CITY OF STOCKTON

Site Plan Review Comments for P21-0905 (1515 Fresno Av; APN: 163-370-34)

RE: Site Plan Review and Design Review Application (P22-0020) for 1515 Fresno Av; APN: 163-370-34.

DATE: AUGUST, 2022
SCALE: AS SHOWN
DESIGNER: SP
DRAWN BY: MRF
JOB NO.: A20664-1
SHEET: **2.0**
OF 3 SHEETS

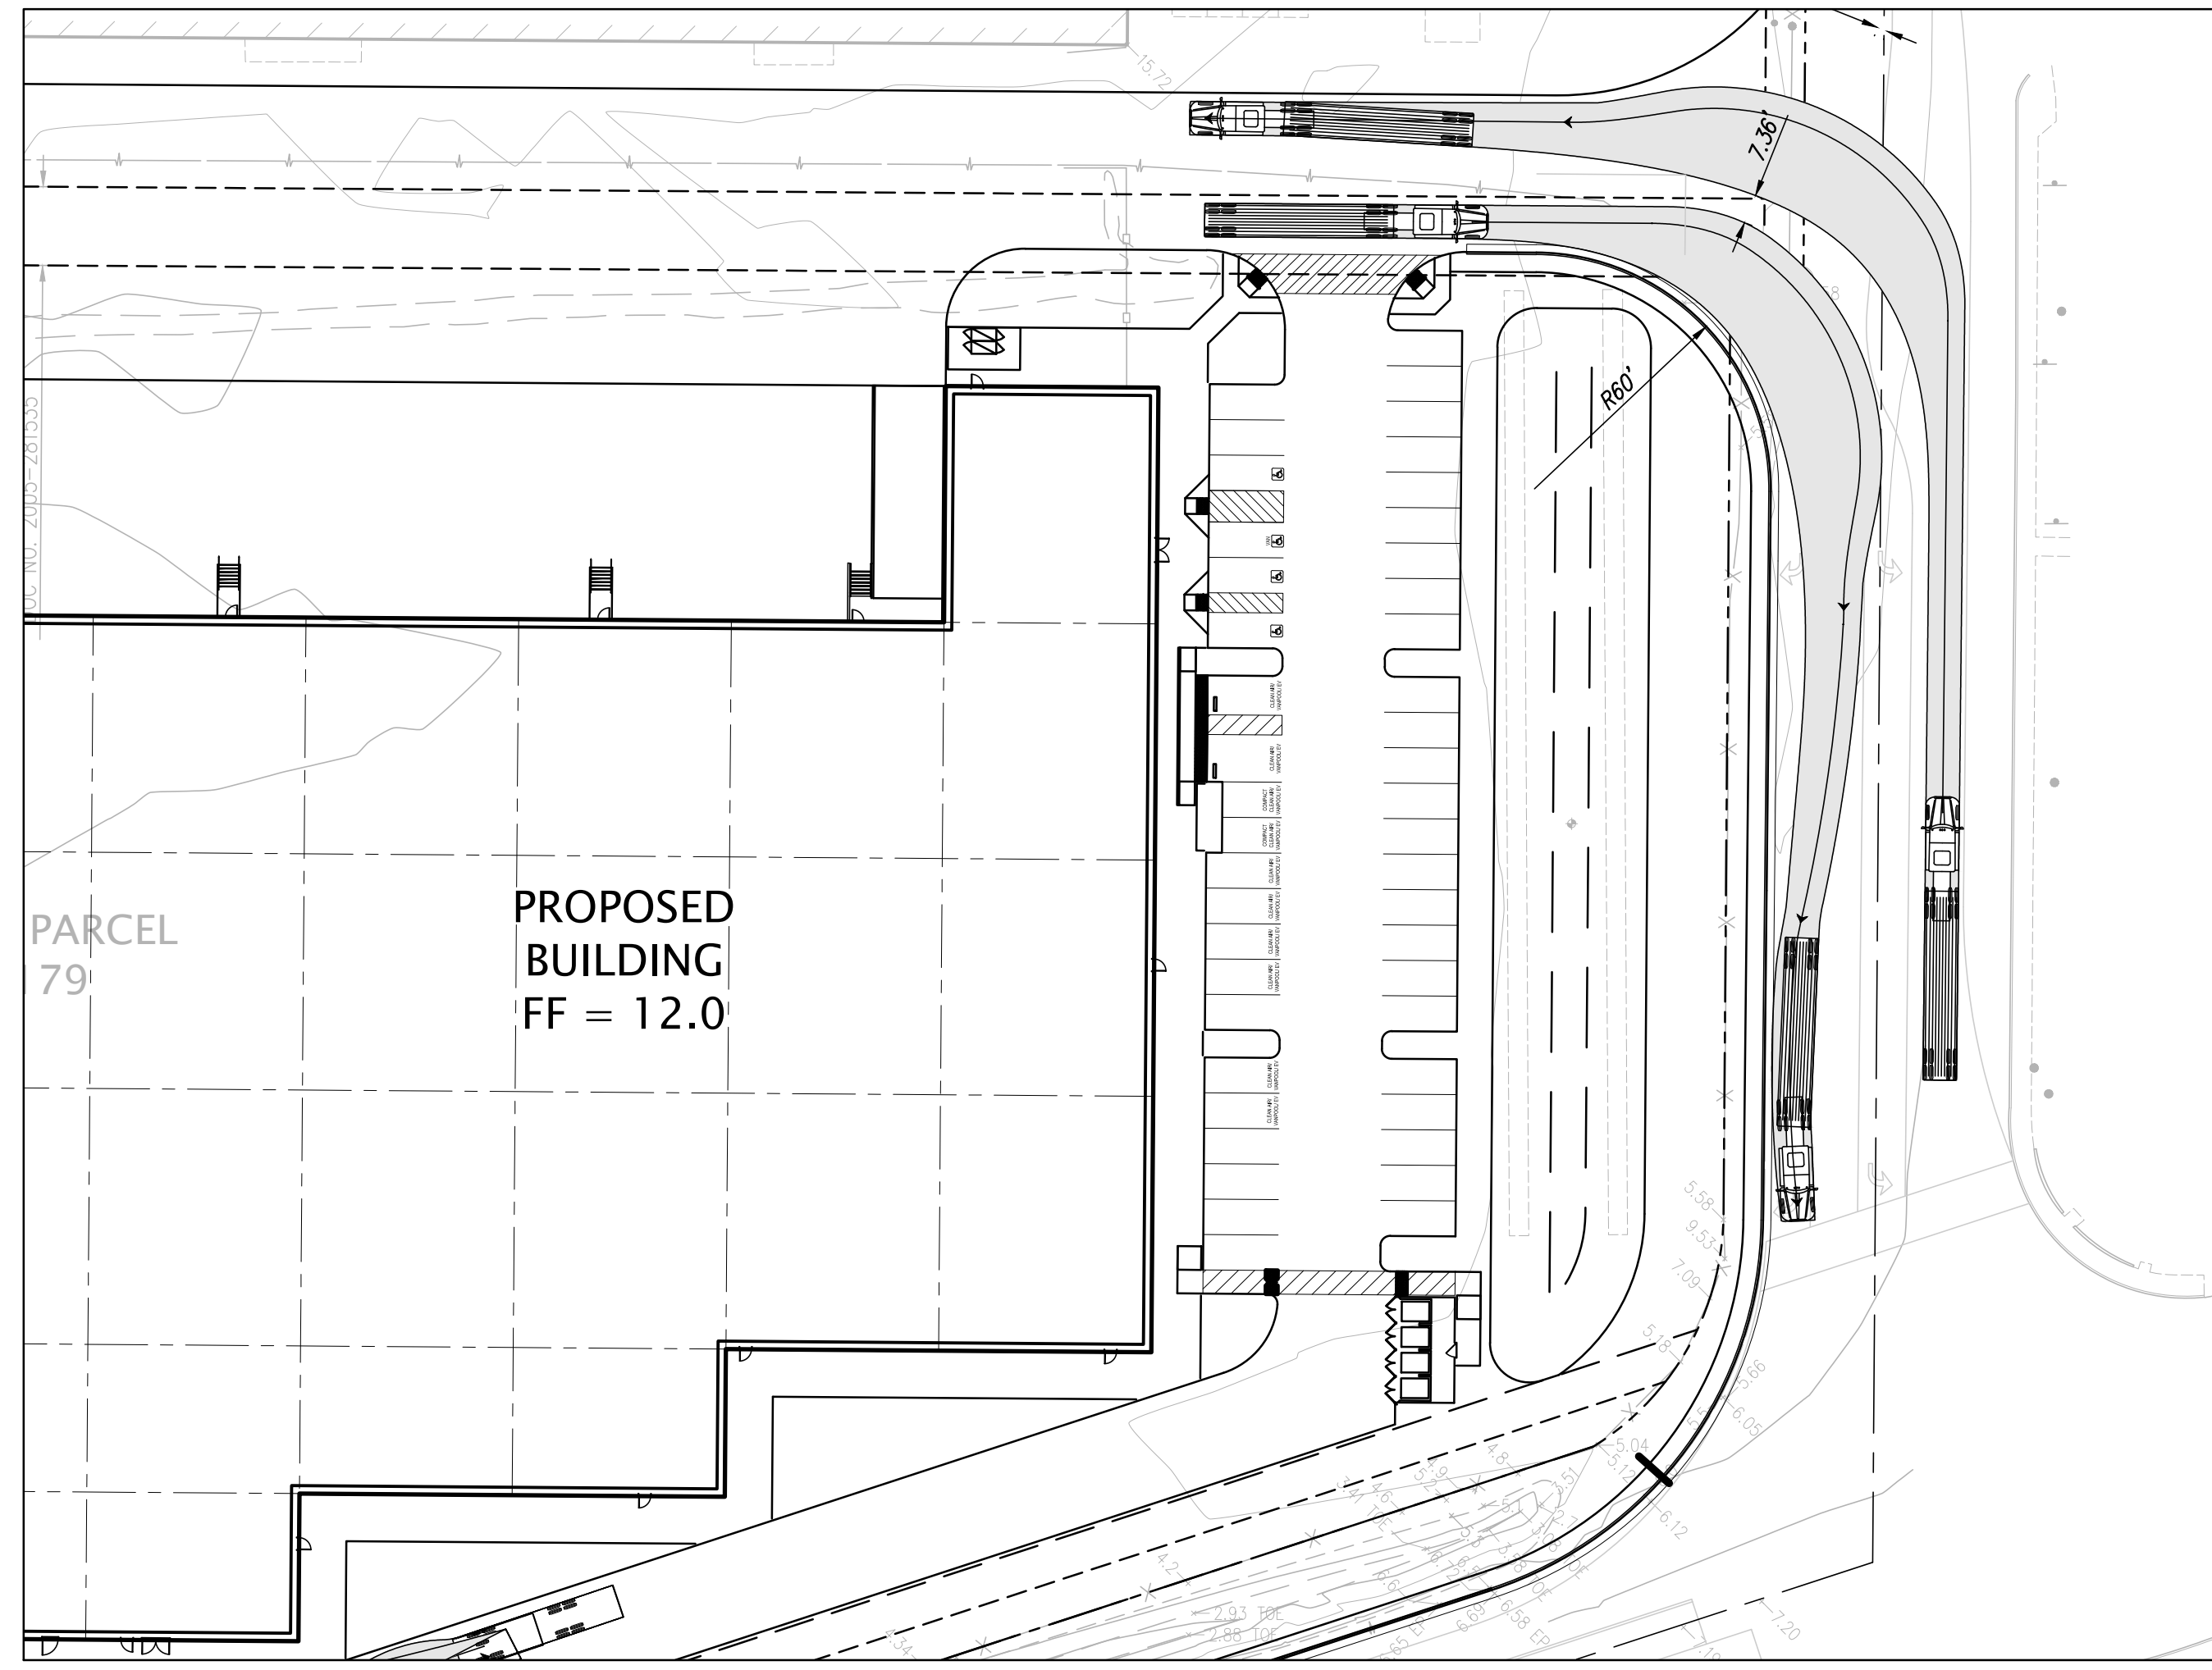
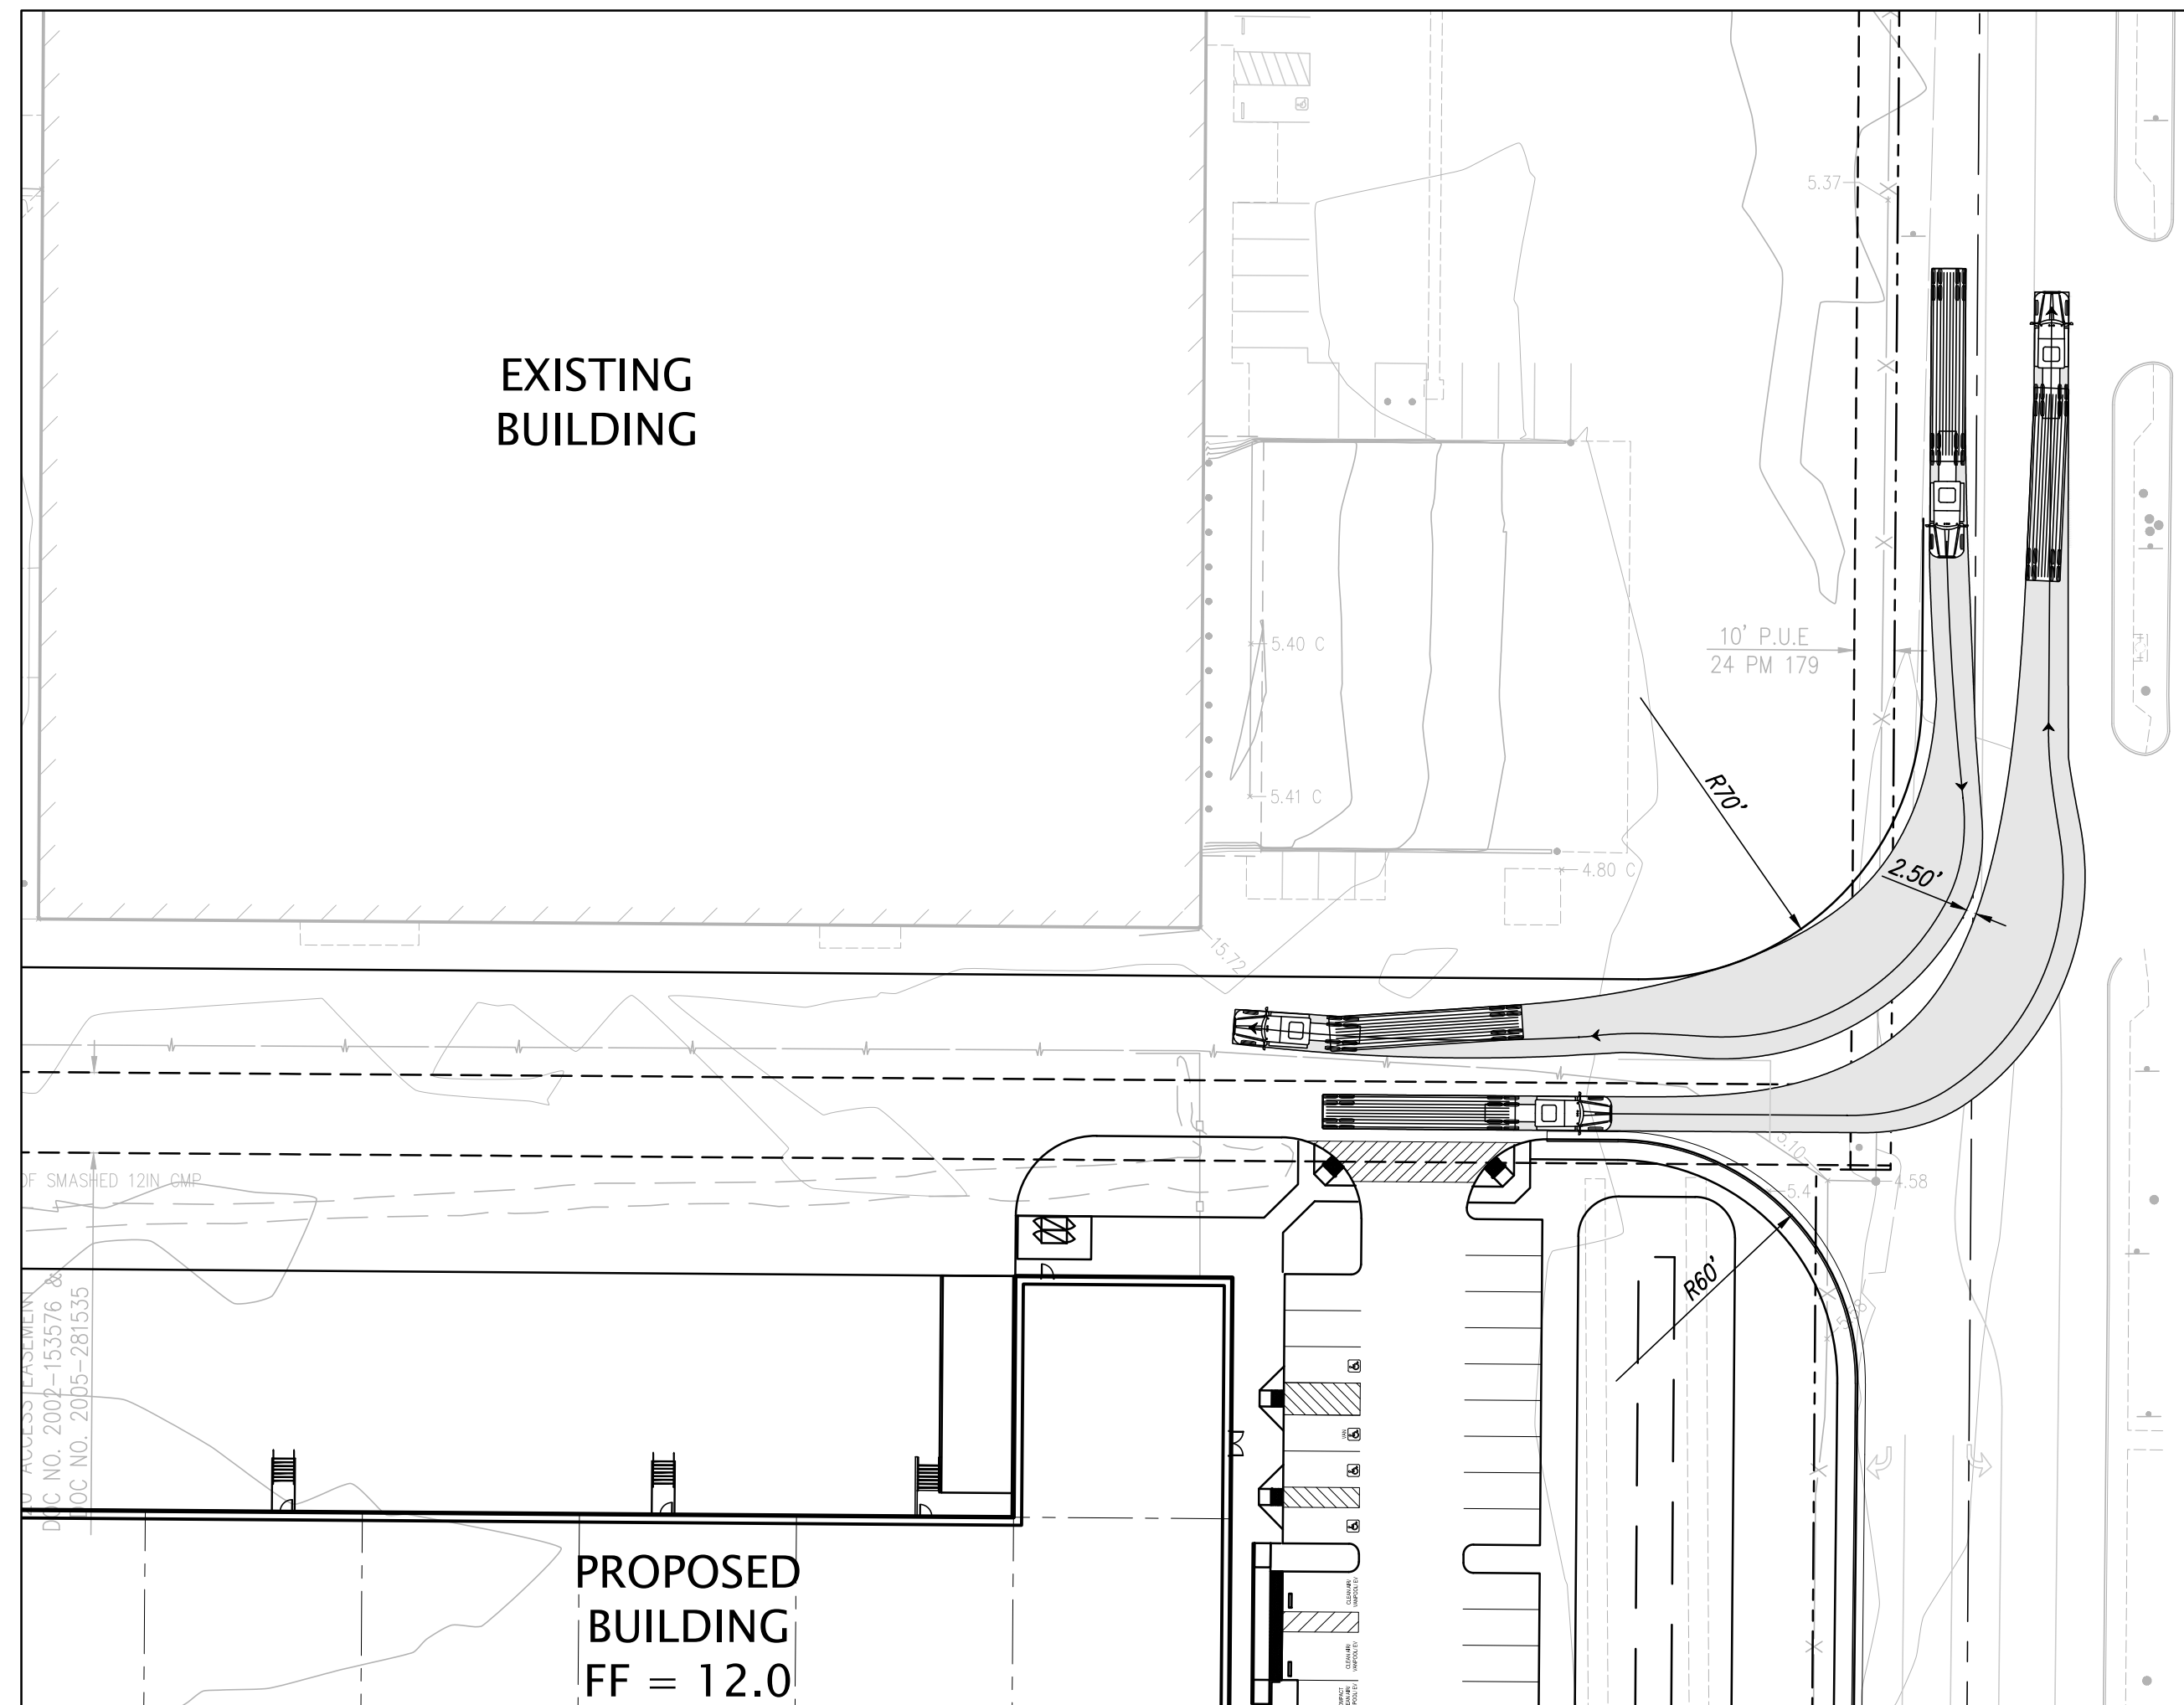
6. Prior to building permit submittal, the applicant shall revise the Fresno Avenue – Left Turn Exit and Right Turn Entrance Truck Turn diagram (Page 31 of Exhibit 1, Sheet 2.0) to indicate a 3-foot minimum distance between southbound incoming trucks and northbound outgoing trucks.
